FED. ROAD DIST. NO.	STATE	FED. AID PROJECT NO.	FISCAL YEAR	SHEET NO.	TOTAL SHEETS
HAWAII	HAW.	STP-0300(125)	2011	C.O. ADD. 40	55

STATE OF HAWAII
DEPARTMENT OF TRANSPORTATION
HIGHWAYS DIVISION
DROP STRUCTURE PLAN
SECTIONS AND DETAIL
CASTLE HILLS ACCESS ROAD
Drainage Improvements, Phase 2
Federal-Aid Project No. STP-0300(125)
Scale: As Shown Date: Dec. 2011
SHEET No. S23 OF 17 SHEETS

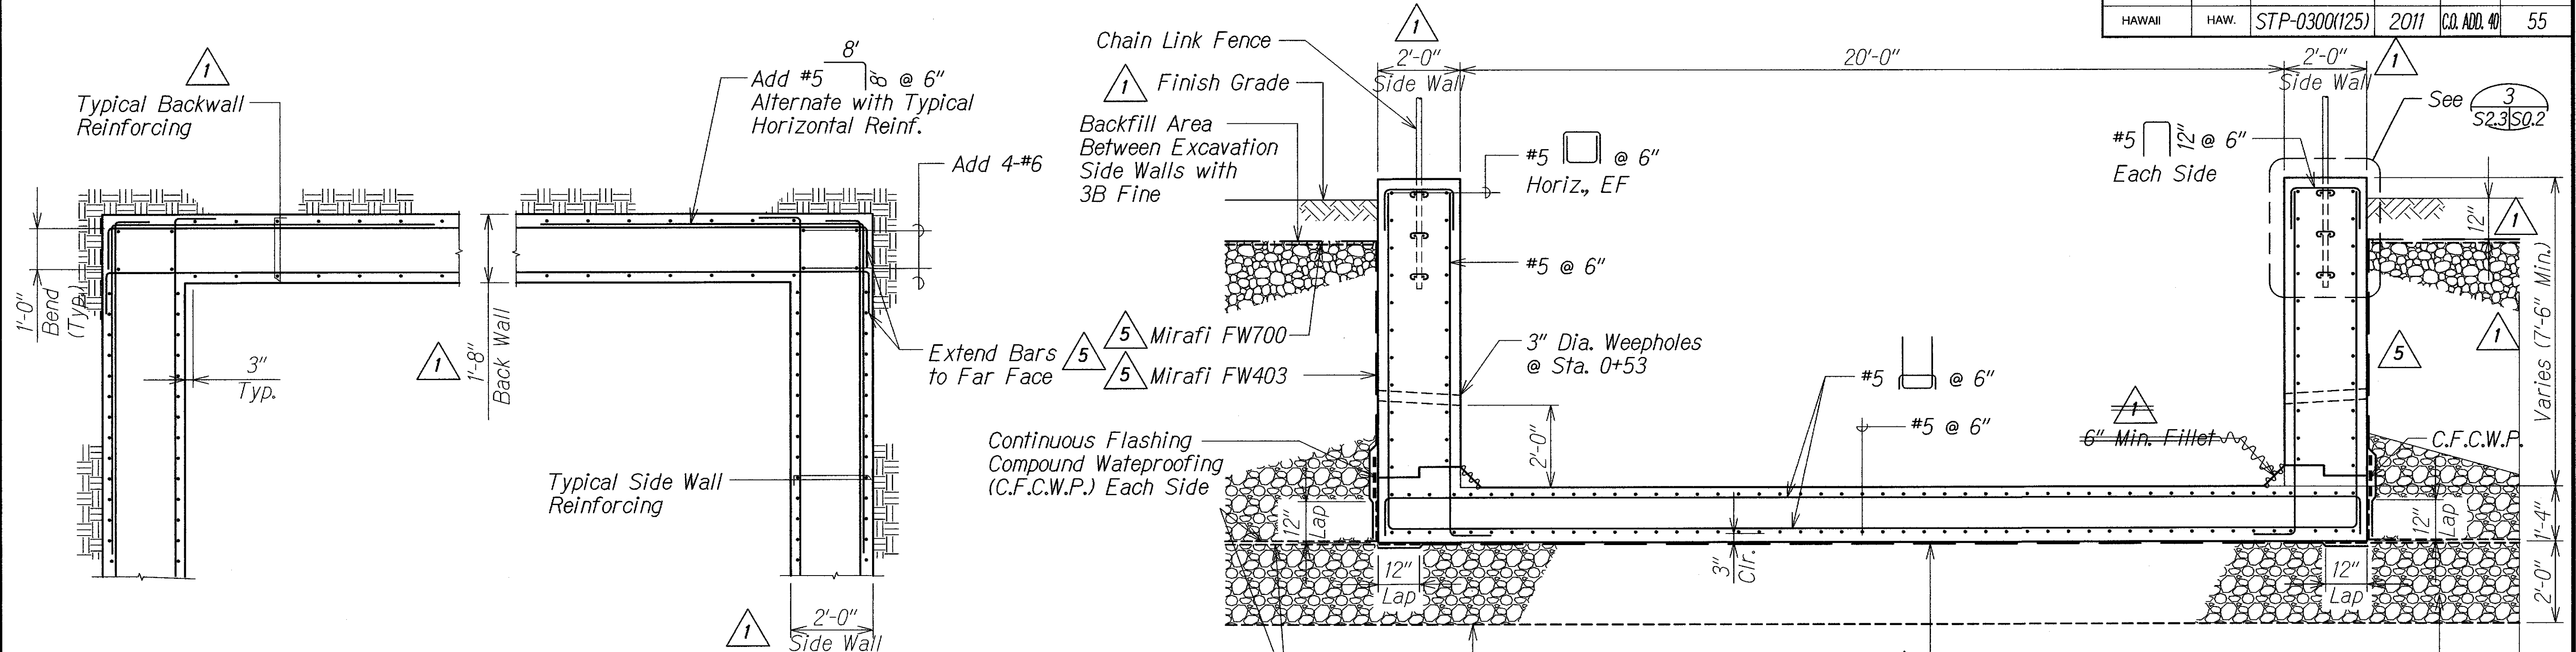
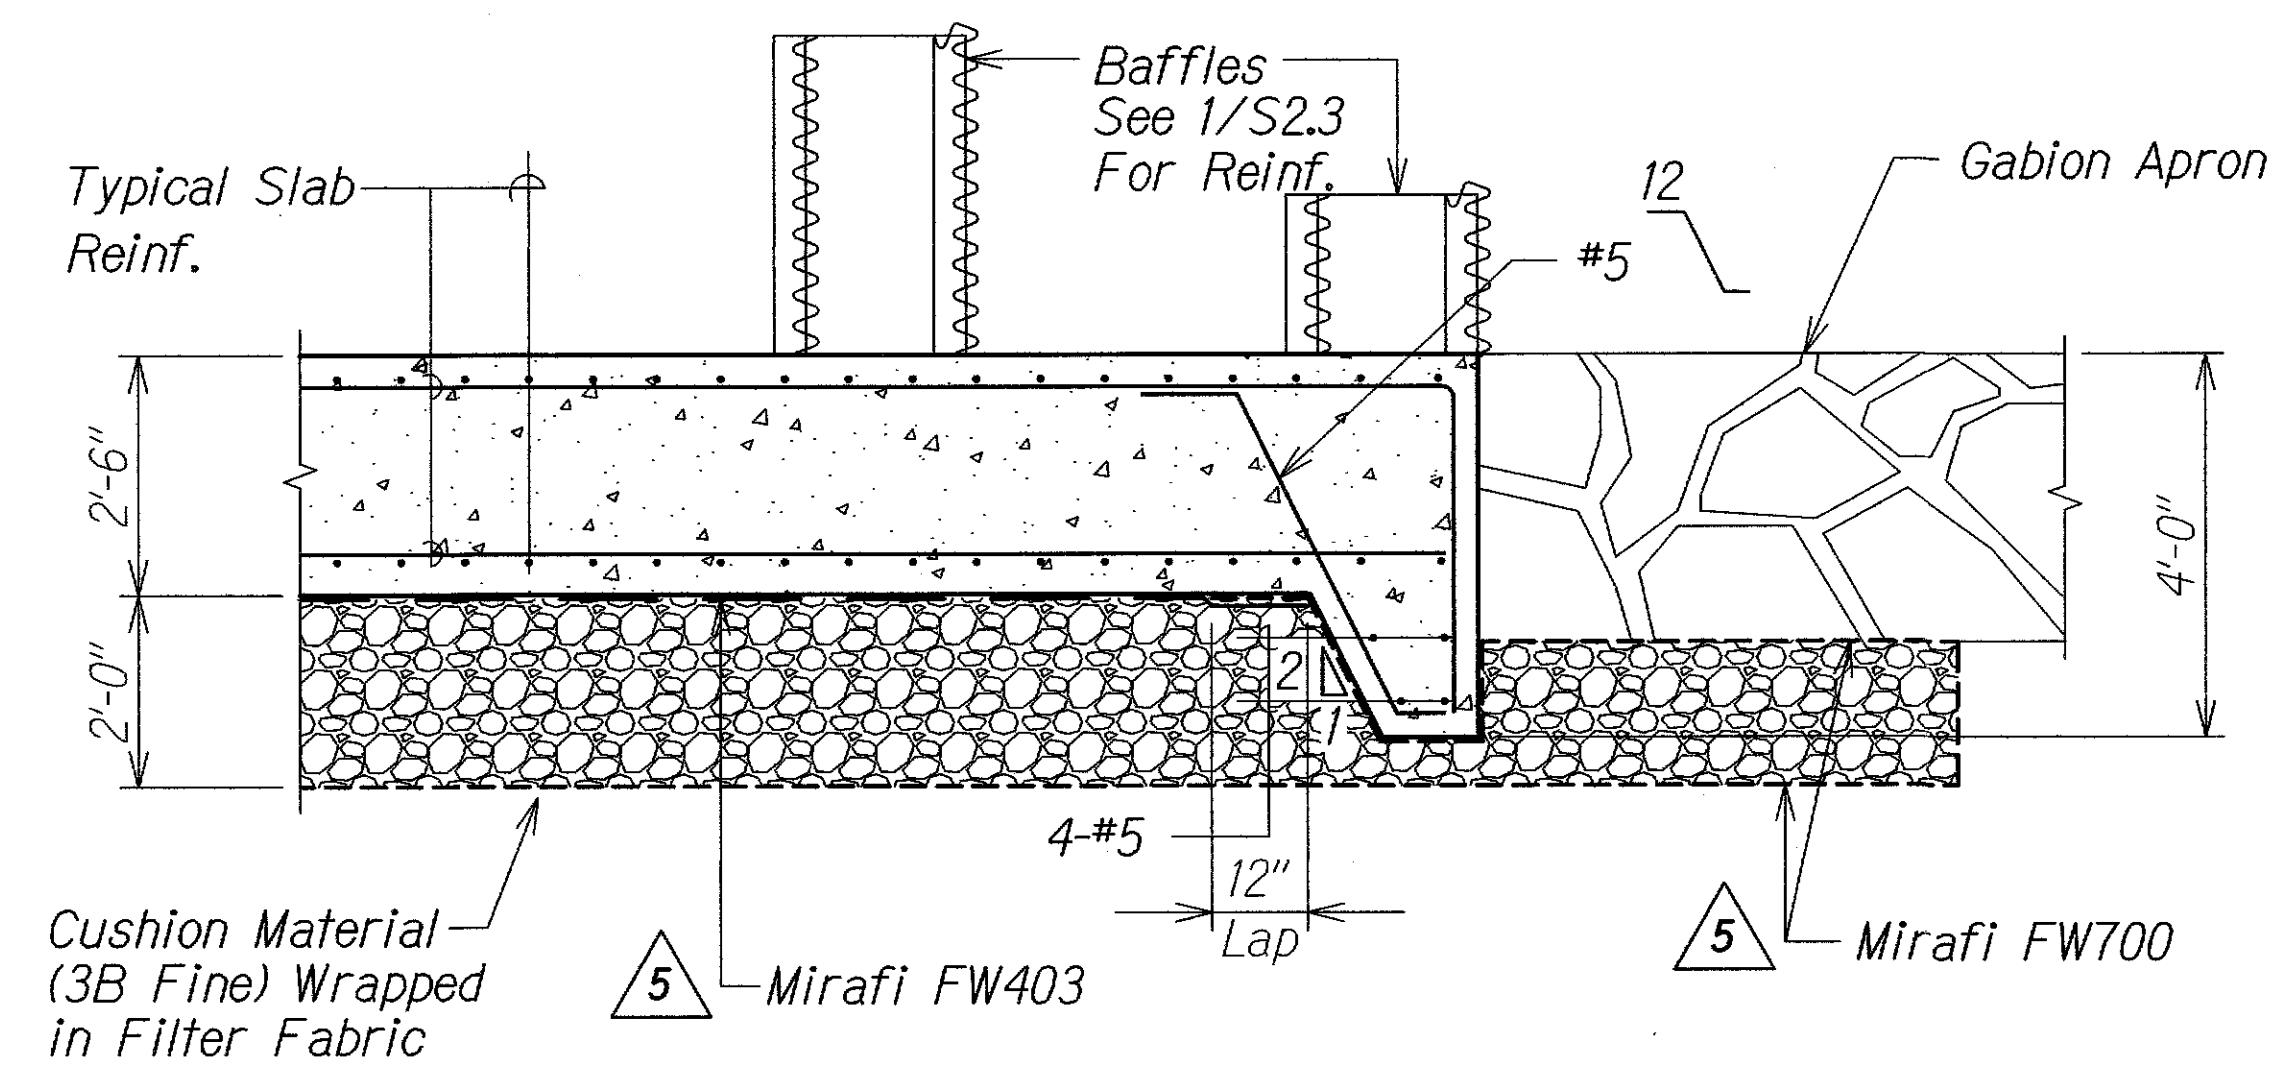
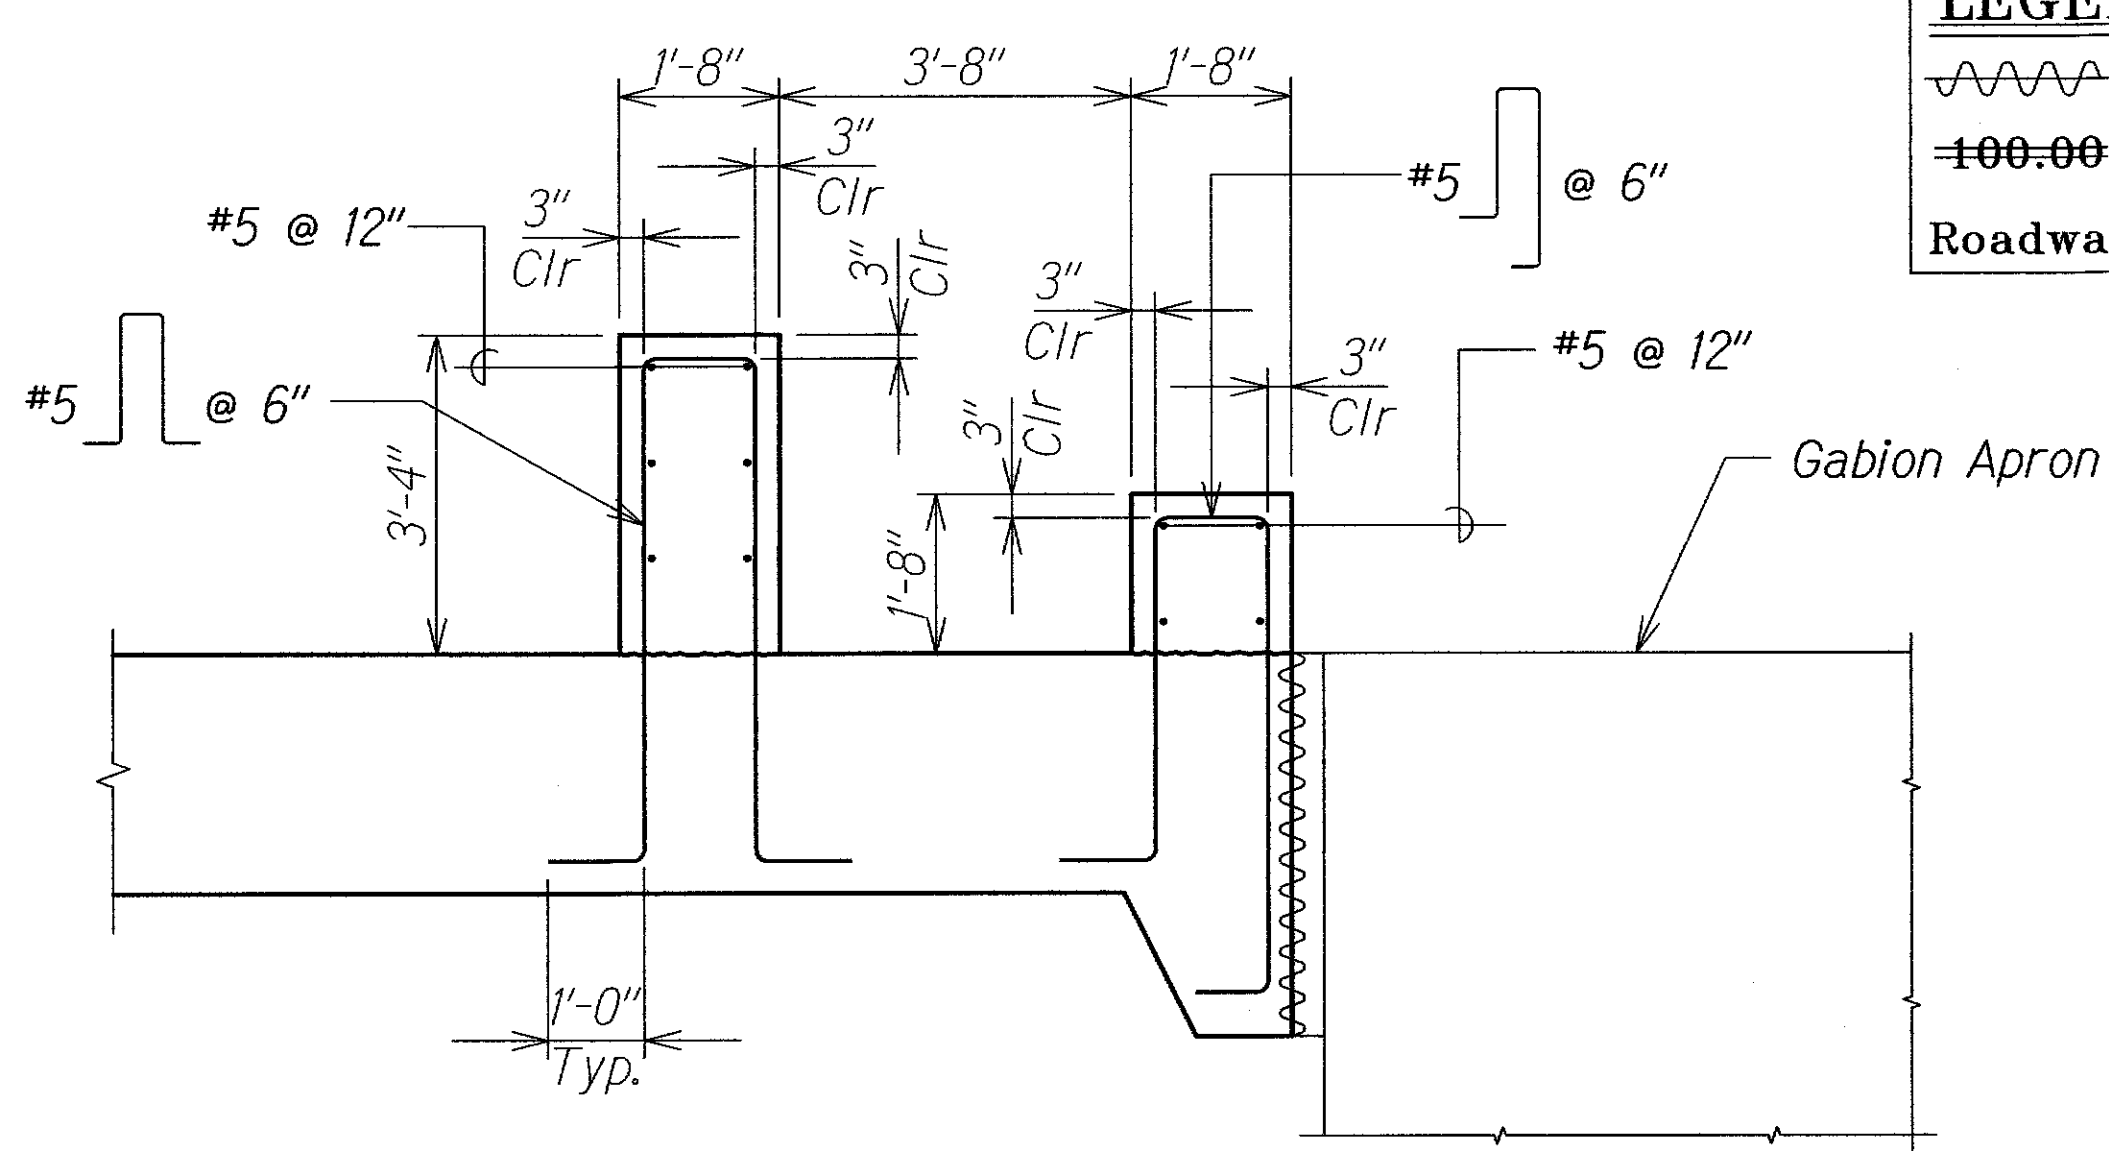
DATE	REVISION
06/09/14	5 Change Order - Remove Filter Material. Location & Extent of Geogrid & Geotextile
01/19/12	1 Note Clarification.
